Subject: Transmittal of Revision 1 to Service Bulletin V2500-ENG-77-0075

AIR - HP COMPRESSOR VARIABLE STATOR VANE ACTUATOR - INTRODUCTION OF REVISED
TORQUE MOTOR STRAINERS

ENGINE COMPRESSOR CONTROL - VARIABLE STATOR VANE ACTUATOR INTRODUCTION OF TORQUE MOTOR WITH REVISED FILTRATION TO PREVENT BLOCKAGE WITH FUEL DEGRADATION PRODUCTS

(LUCAS AEROSPACE MOD. D.TV.059)

VSVA Identification
Figure 1

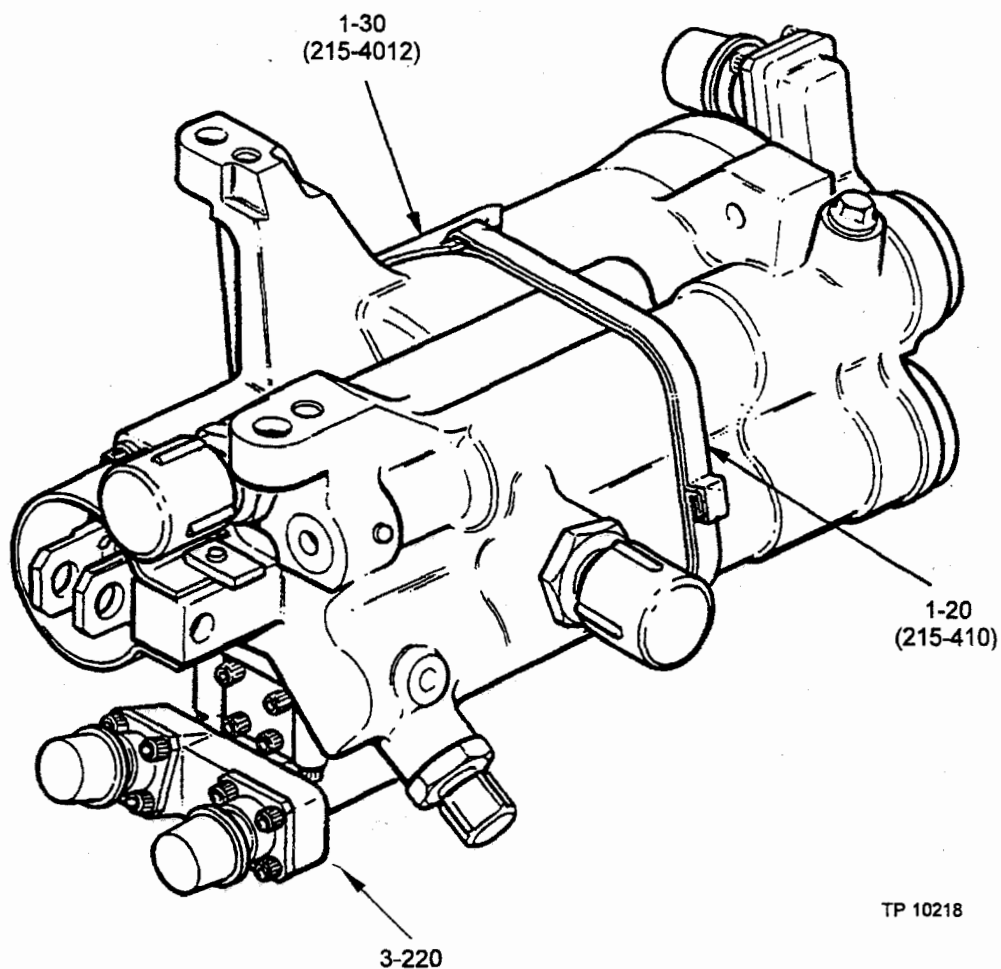
This Service Bulletin (Modification) introduces a Torque Motor with revised filtration to prevent blockage by fuel degradation products.

2. Accomplishment Instructions (Fig 1)

Install the Torque Motor in accordance with the Component Maintenance Manual. Existing Torque Motors can be reworked by the manufacturer (Moog Controls Ltd).

- (1) When ASSEMBLY is complete, get the new identification plate (1-30) part no. 215-4012 and strap (1-20) part no. 215-410 supplied with the Mod. Kit.
- (2) Refer to the information marked on the first identification plate (1-30) and mark the new identification plate as follows (use 1/16in. (1,6mm), letter/number stamps). Use the stamps with the identification plate held on a flat surface:

TYPE No.	MARK: 1685 Mk 7	(SB1685-75-007 (D.TV.055) must be incorporated at the same time if the unit is a Mark 6.	
SERIAL No.	Mark as on the original plate		
MOD No.	Mark on the plate:	Installed Unit	Replacement Unit
	D.TV.059	1655-4009	2607-9000
	D.TV.016, D.TV.059	1655-4009	2607-9001
	D.TV.016, D.TV.046, D.TV.059	1655-4009	2607-9002
	D.TV.016, D.TV.059	1685-4016	2607-9001
	D.TV.016, D.TV.046, D.TV.059	1685-4016	2607-9002
	D.TV.016, D.TV.046, D.TV.059	1685-4045	2607-9002
INSP.	Keep blank		
TEST	Keep blank

- (3) Fill the stamped letters and numbers with black paint and wipe away the surplus.
- (4) Install the new identification plate (1-30) on the unit with the new strap (1-20).
- (5) Discard the first identification plate.
